Applicant response to consultee observations

Subject: FW: MS51/6/333 Foreshore Licence Application Great Island Gas pipeline & 6/333a site investigation licence.

Subject: RE: Proposed Foreshore Licence Application for ancillary ducting to Gas Pipeline to Great Island

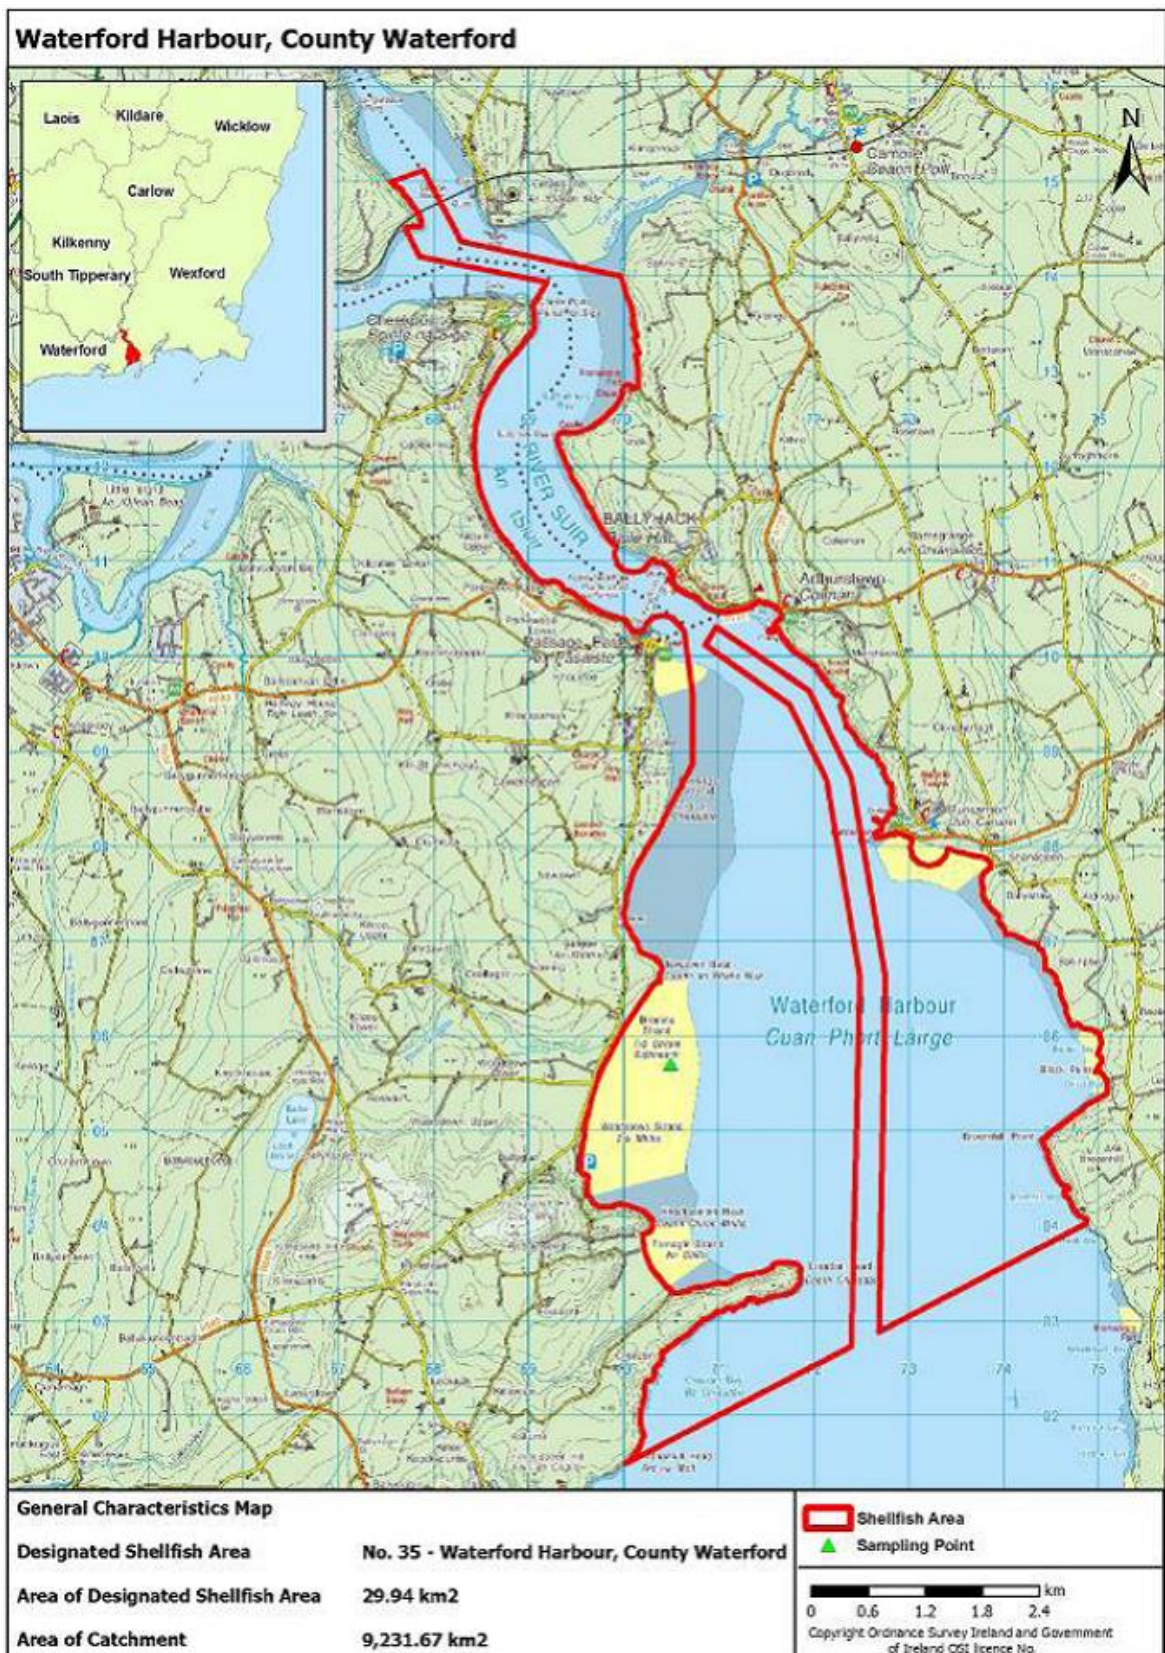
The Sea Fisheries Protection Authority is concerned about a possible release of bentonite affecting the cultivated mussels downstream of the proposed site. Could you please confirm that any such release will not directly affect the mussels as an animal and will not accumulate in the mussel and render the animal unsafe to eat?

- 1 Bentonite is an inert, naturally-occurring material.
- 2 The Designated Shellfish Area downstream of the proposed site is two kilometres distant at the closest point (Designated Shellfish Area No. 35, Waterford Harbour). The location map for the Designated Shellfish Area is included below.
- 3 Although no release of bentonite to the Estuary is envisaged, the maximum possible volume of accidental discharge is 20 to 30 cubic metres.
- 4 A risk assessment of the potential for accidental release of bentonite has been completed – this is summarised in the table below. The risk is considered to be low.
- 5 At this location in the Estuary, there is a very large volume of dilution available.
- 6 Estuarine environments tend to have natural levels of suspended solids arising from re-suspension of mud particles, and mixing of fresh and salt water.

8 In the unlikely event of a bentonite release, allowing for natural mixing, dispersion, dilution and settlement over the two kilometres between the pipeline crossing location and the closest point of the Designated Shellfish Area, no significant effects on the commercial mussel farming activities are predicted – either direct effects on the mussels as an animal, or in the form of accumulations in the mussels which could render the animal unsafe to eat.

We confirm that the pipeline crossing depth will be a minimum of 10 metres.
